CERTIFICATE OF APPROPRIATENESS PLACARD

407 POLK STREET

Certificate Number

- Replace non-historic dormer window;
- reside dormer;
- change exterior paint colors;
- replace non-historic railing.

PROPOSED HANDRAIL REPLACEMENT

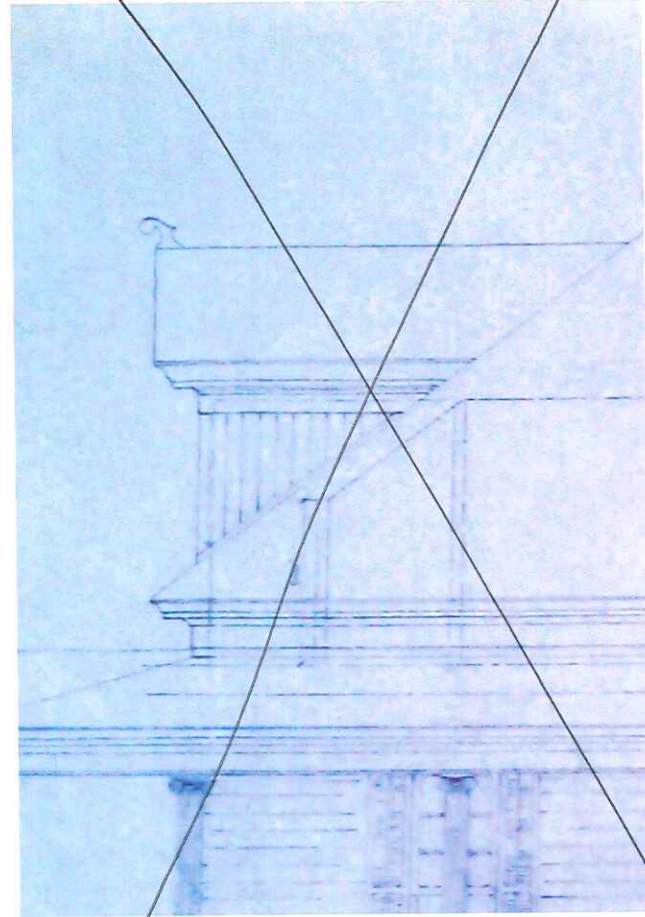
Max height
Per 8/1/14
email
TGT

2. Is a new handrail proposed in any other location on the porch? **No other location besides replacing what is existing (recently added).**
3. Can you confirm that the replacement railing will be no taller than the existing new railing at any point? **Yes, new handrail will not be taller than existing anywhere.**

PROPOSED DORMER SIDING REPLACEMENT

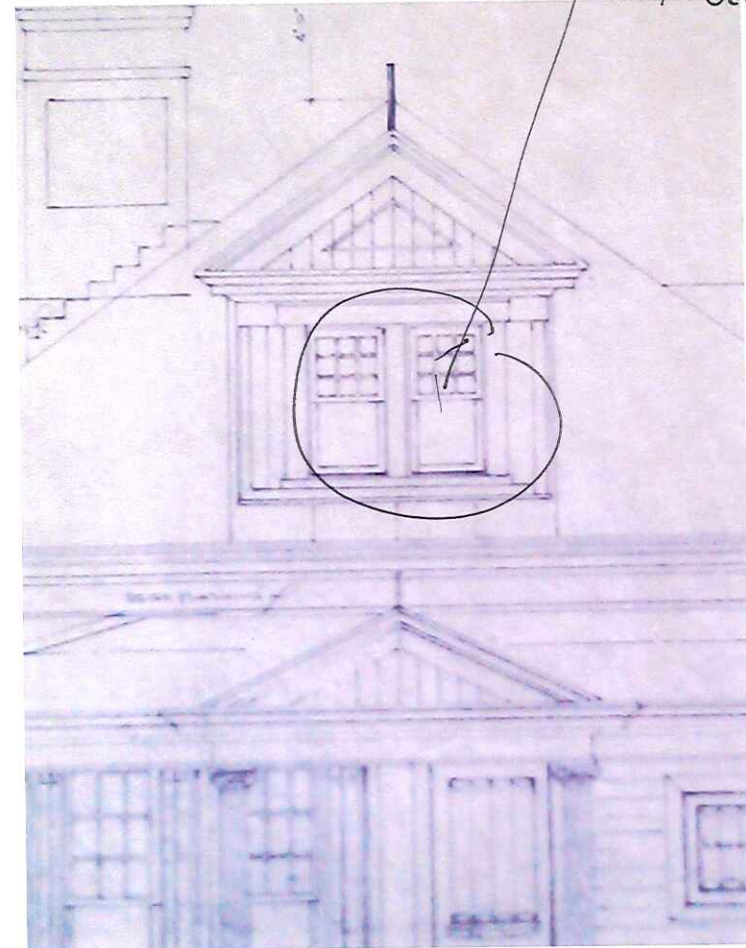
horizontal
per 8.13.14 phon. con v.
TGT

Thanks for the answers. As for your question, I personally think that horizontal siding is more typical of what we see in Oakwood. I am comfortable approving the vertical based on the 1977 COA approval, but agree with Darrow that the horizontal is more appropriate.

★ per 8.13.14 Phone Conversation dormer will have lap siding & corner boards w/ 1/4 round to match existing on house.

PROPOSED DORMER WINDOW REPRODUCTION

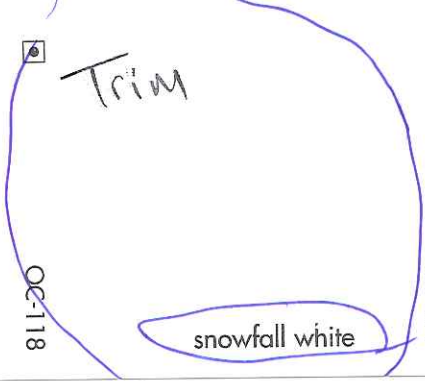
*fit in existing
opening. Custom
wood windows
by Oak City*

*Artisans,
per 8/1/14
email,
167*

4. I looked in the COA file and found the COA application from 1977 for which your drawings were likely created. ☺ **Excellent!**
5. It is your intent to use the 1977 drawings as the basis for the dimensions of the altered dormer/windows? **Yes. The drawing has been scaled for sizing, in addition to uncovering the original rough opening framing for the window, we are within 1" of original sizes.**

6. Will the two new windows be custom made by you/your crew? **Yes, all custom made from SYP to match original sill, profile, layout, etc. Will utilize weight/pulley system for operation.**
